Re: Trapper GW addendum ADQ

The picture below shows the current permit boundary (pink) and Map 54K overlain on Map 4, (both maps are proposed with PR-11 - not yet approved).

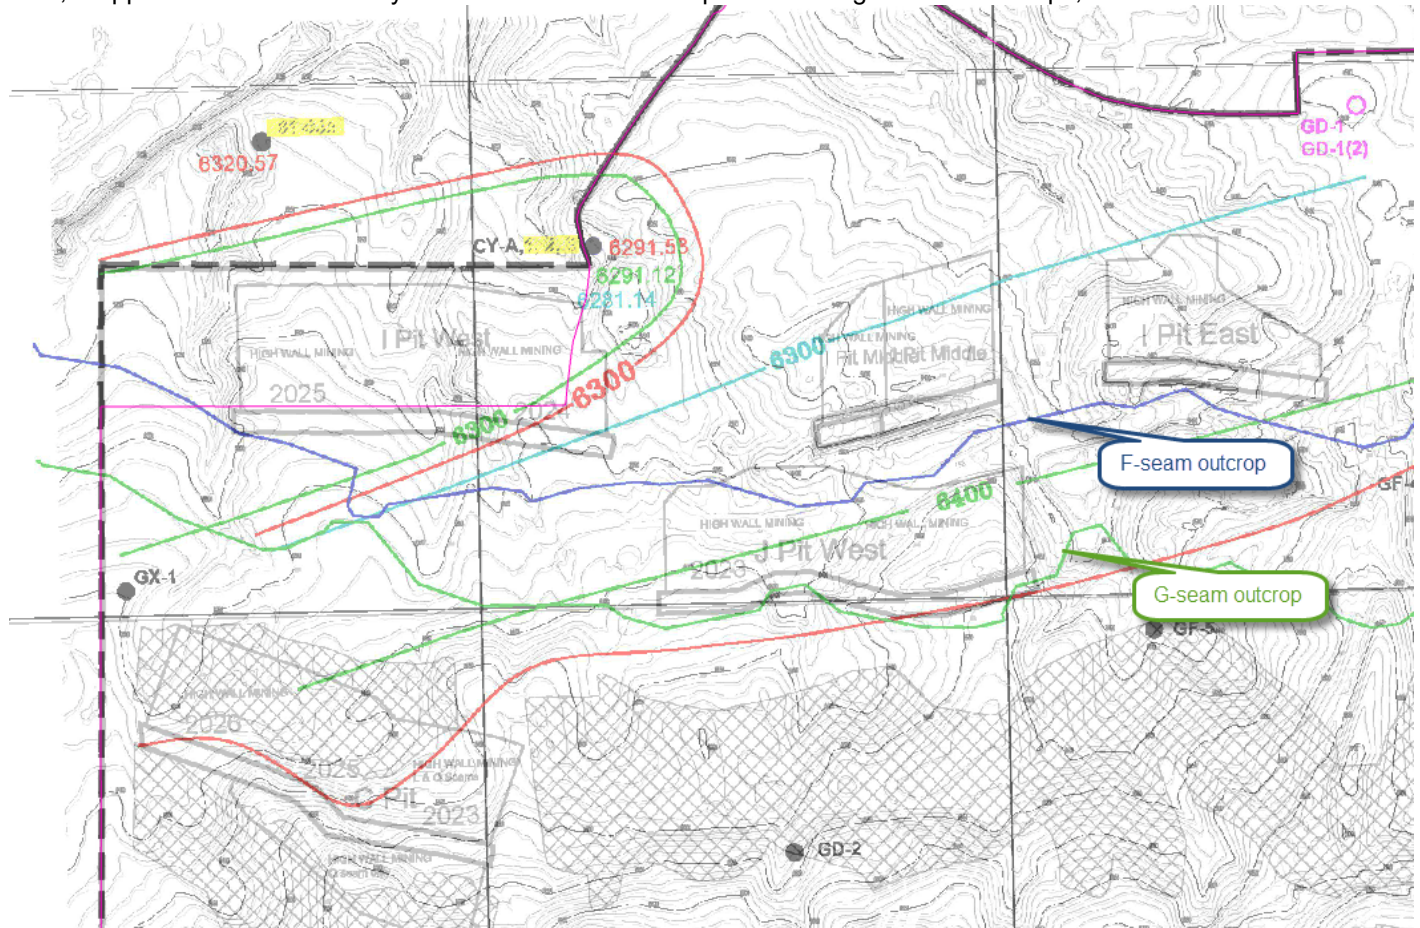
Map 4 has the pit boundaries. Map 54K has the outcrops of the F and G seams (jagged blue and green lines), and the projected potentiometric surface of water in the 1st white (light blue), 2nd white (green) and 3rd white (red) sandstone aquifers. We don't see the outcrops of the sandstone units, but we can guess their approximate location.

1. Although the water in the 1/2/3 white sandstones has not been classified by the WQCC, the fact that 5 domestic supply wells have been completed in them in the small area we're concerned with suggests that the water is of good quality - Trapper says as much somewhere in the text of the PAP, I just can't find it right now. There is text in the PAP that discusses mitigation of impacts to well owners, but there is no text discussing mitigation of impacts to the aquifer itself.

2. A groundwater point of compliance must be downgradient of the disturbance/potential contamination - in this case the two backfilled pits. The current monitoring wells CY-A, CY-1, CY-2 and CY-3 are completed in the alluvium, 1st white, 2nd white and 3rd white respectively, but they are all at the same location (see the first picture). I don't think it's reasonable to say that a single point can be downgradient of both pits. In fact, based on the projected potentiometric surface given on Map 54K (which I am not ready to accept as accurate without more information), those wells are actually upgradient of the I-pit west.

3. If Trapper were to characterize the three aquifers more thoroughly and to provide sufficient evidence that the projection of the potentiometric surface is accurate, and then agree with the Division suitable locations for points of compliance, we would have to apply the interim narrative standard at those points. Precisely how that standard will be applied is not straightforward, but to take a simple example Table 4 from Reg. 41 specifies that the limit for TDS will be 1.25x the background level. We know that the water recharging the 2nd and 3rd whites, will have to flow through the backfilled pits. Does Trapper have evidence from elsewhere on the site or from modeling to suggest that they would meet the standard?

4. Suppose the mine plan were to go ahead as proposed, and following backfilling of the pits the water quality at the points of compliance was found not to meet the standard. How would Trapper be able to mitigate the impacts they had caused? How would the Division be able to release the site?

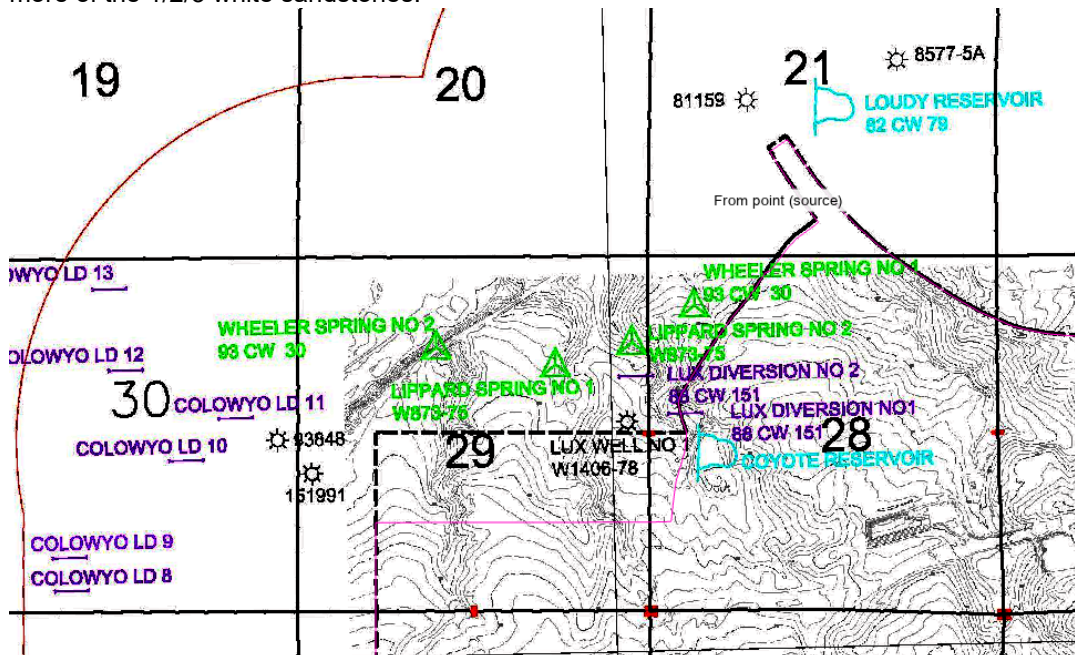
Here's another picture: this shows part of Map 31 (proposed with PR-11). We can see 5 permitted wells in the area (black symbols). According to the DWR database, they are all used for domestic water supply. DWR doesn't identify the aquifer they are completed in, but their depths range from 200' to 700' which suggests that they could be completed into one or more of the 1/2/3 white sandstones.

Impacts to the 5 wells are discussed in Section 4.8.2.2 (approved with PR-10). Trapper commits to "replace the water supply of any owner of a vested water right which is proximately injured as a result of the Trapper Mine."
